CITY OF OPELIKA HISTORIC PRESERVATION COMMISSION

October 9, 2025

HISTORIC PRESERVATION COMMISSION MINUTES

September 11, 2025

Addition of sidewalk at side parking area

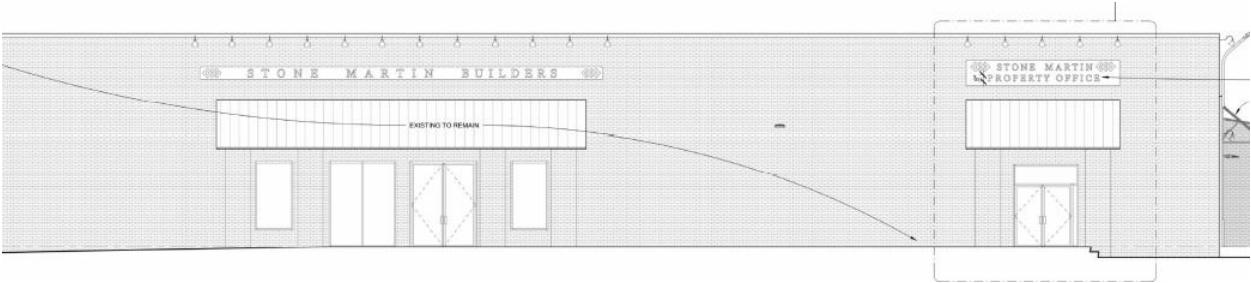
1. A new concrete walkway will be added to the northeast end of Stone Martin's existing parking lot to enhance wayfinding and access to the new Design Center. The size and location are shown on the drawings.

1. Staff recommends approval of new concrete walkway at parking area on 1st Ave side for Design Center.
2. Staff recommends approval of revised painted signage matching the style, size, and color of the existing sign meeting sign regulations.

Change signage above right entrance

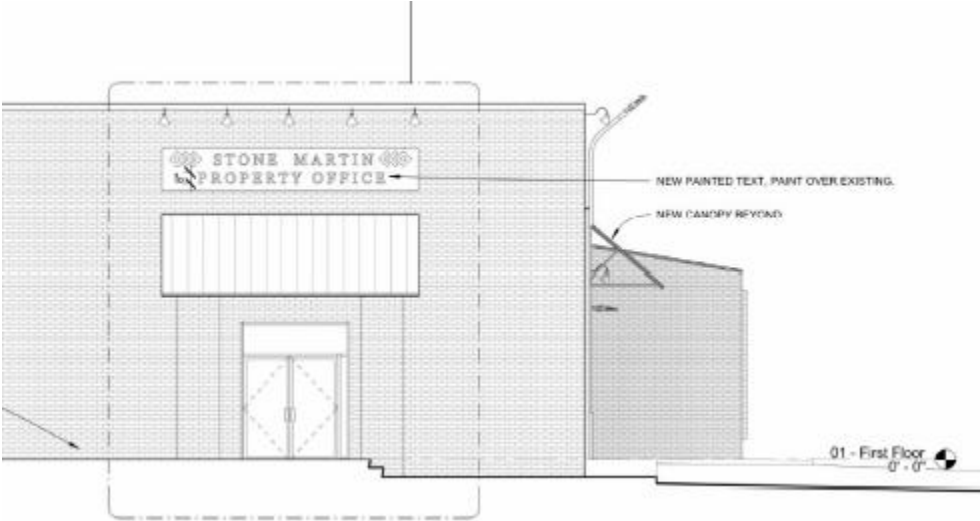
2. The existing sign facing N. 9th Street that reads "Stone Martin Commercial" will be altered to read "Stone Martin Property Office". The style, size, and color of the lettering will not change.

Proposed changes to 1st Ave side

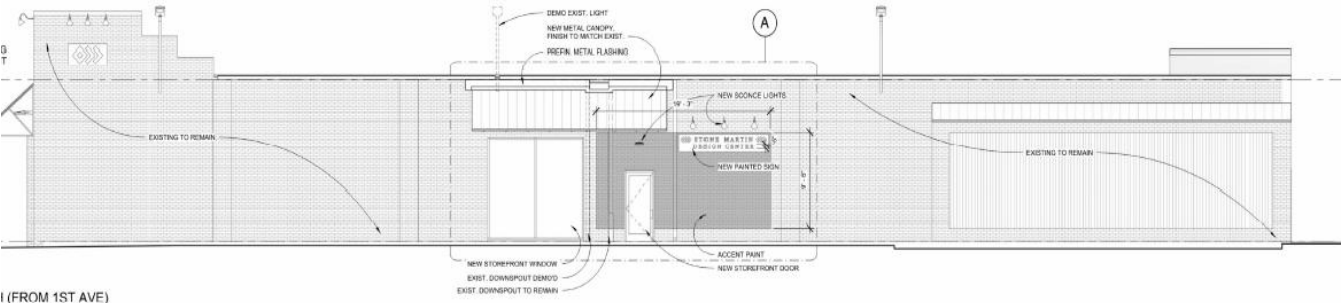
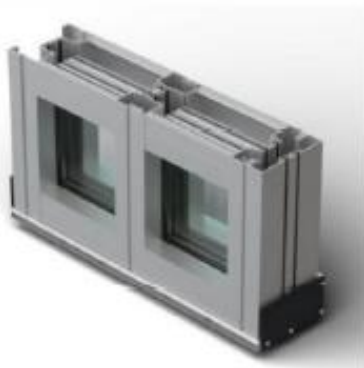
(FROM 1ST AVE)
Facing 1st Avenue- Remove rollup door and install new storefront window and full glass door. Install metal awning, gooseneck lights, and painted signage.
